**Rezoning from “Residential (Group C) 2” (“R(C)2”) and “Open Space” (“O”) zones to
“R(C)4” zone for a Proposed Residential Development
at Lot Nos. 519 RP (part) and 520 RP in D.D. 110 and adjoining Government land,
and
Rezoning from “R(C)2” to “O” zone
at Lot Nos. 121, 137, 138, 139 S.A and 139 RP (part) in D.D. 110
and adjoining Government land, Shek Kong, Yuen Long, N.T.
(S12A Amendment of Plan Application No. Y/YL-KTN/6)
- Further Information No. 5 -**

In response to the departmental comments from Transport Department (TD) received on 17 and 20 July 2026, we hereby submit a response-to-comment table with the Revised Traffic Impact Assessment.

Comments Forwarded from Fanling, Sheung Shui and Yuen Long East District Planning Office (FSS&YLE DPO)

Revised Final Report

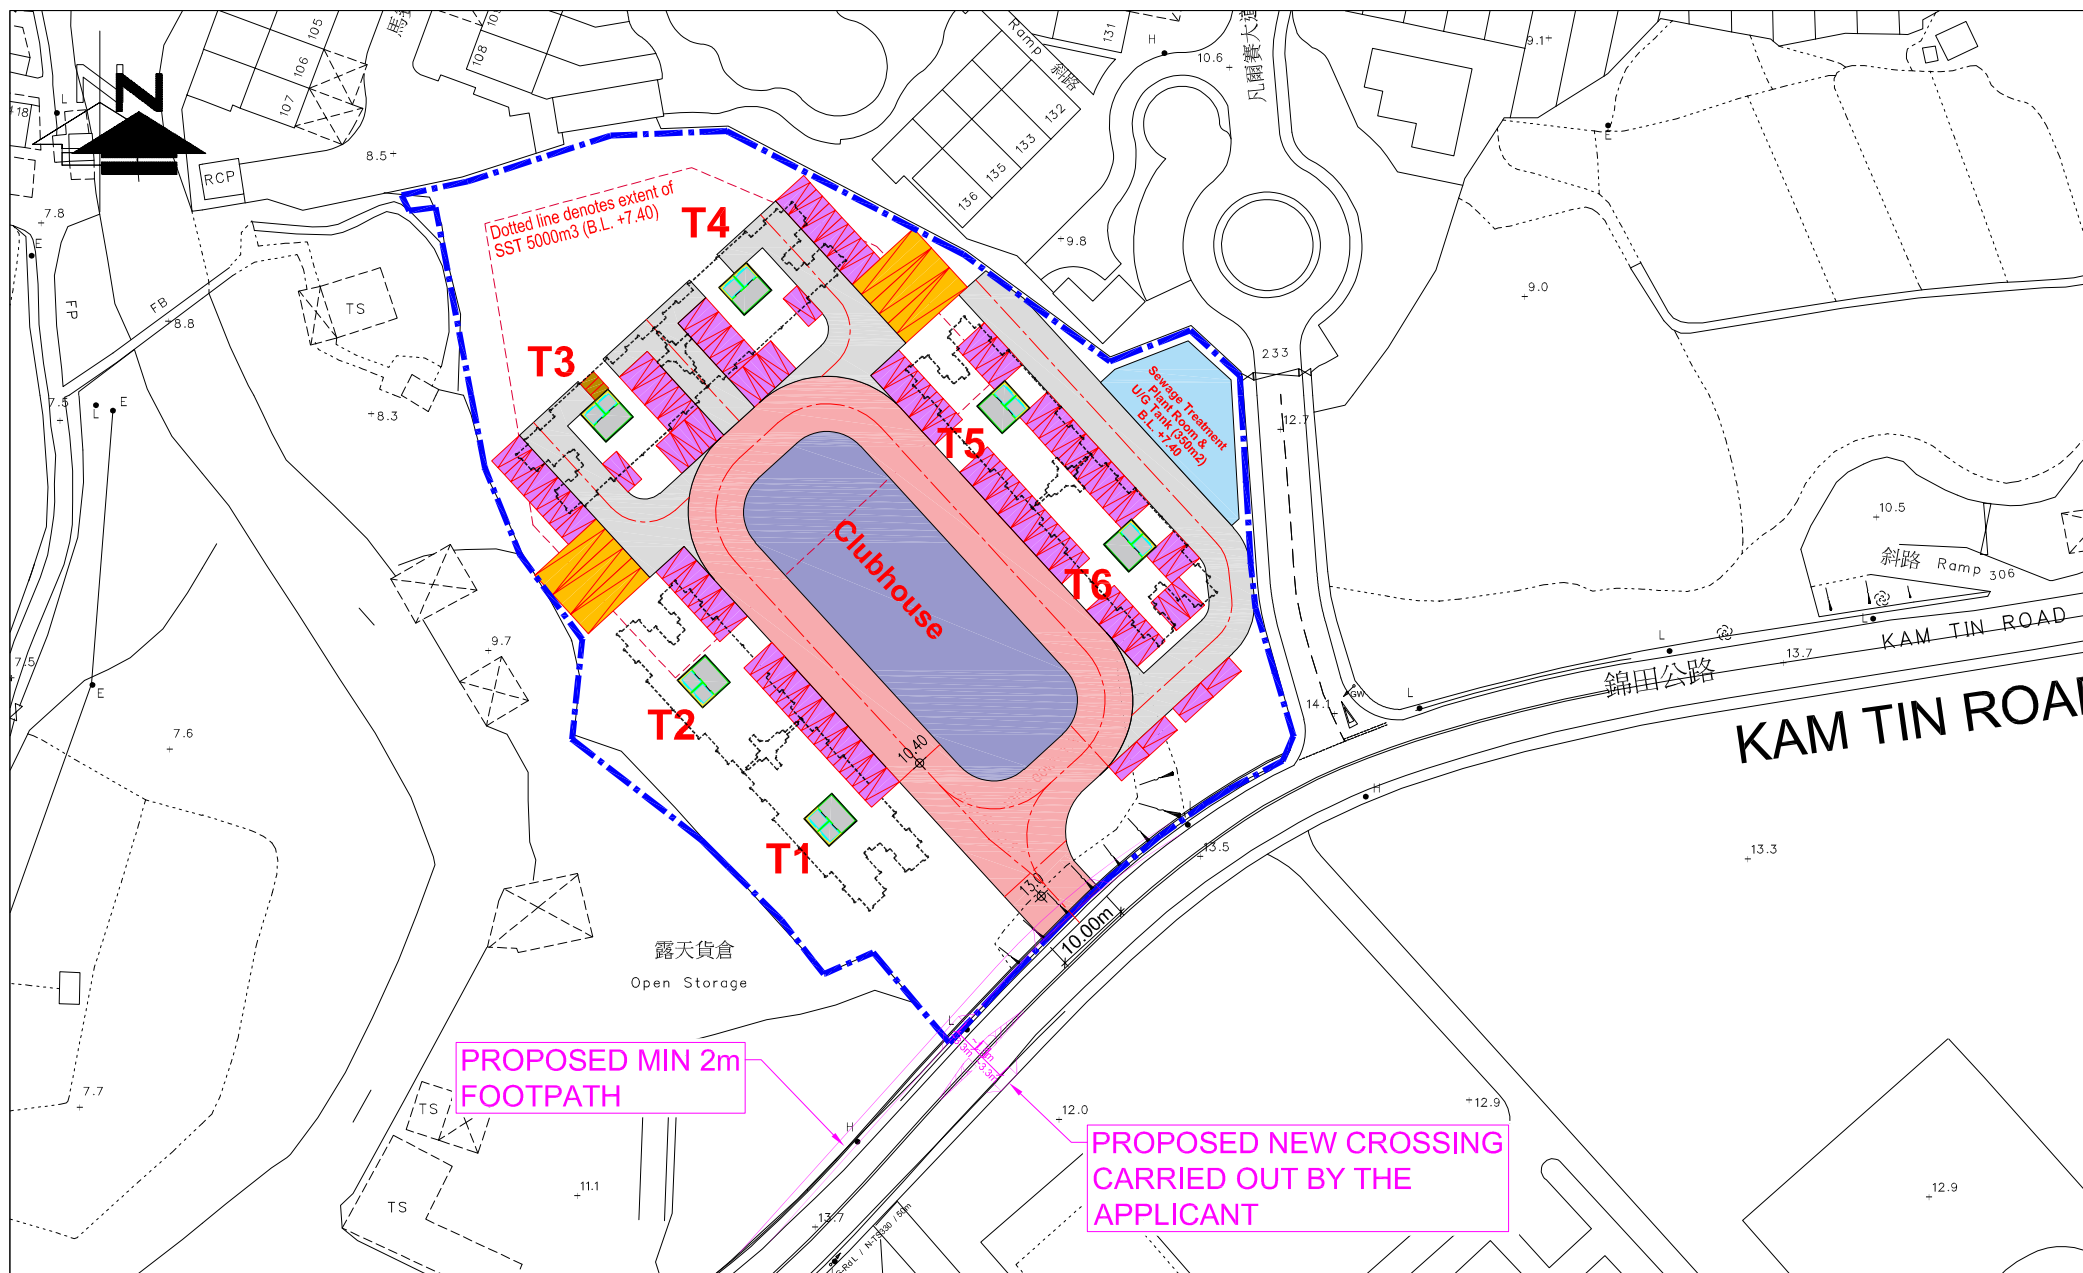
Figure 2.3 - The location of L/UL space is designed away from the towers, e.g. T1 and T6. This could be reviewed during detailed design stage.	Noted. The location of L/UL spaces will be reviewed during the detailed design stage.
Figure 7.3 - According to the TIA, the current footpath along Kam Tin Road at both sides are approx. 1.5m wide. However, due to the presence of street furniture such as beam barriers, lamppost, railing etc., the pedestrian flow arisen from the development may have difficulties going to / from the adjacent attraction, e.g. public transport. The applicant should review	Noted. It is proposed to locally widen the northern footpath of Kam Tin Road to min. 2m as shown in Figure 7.3 of the TIA report.
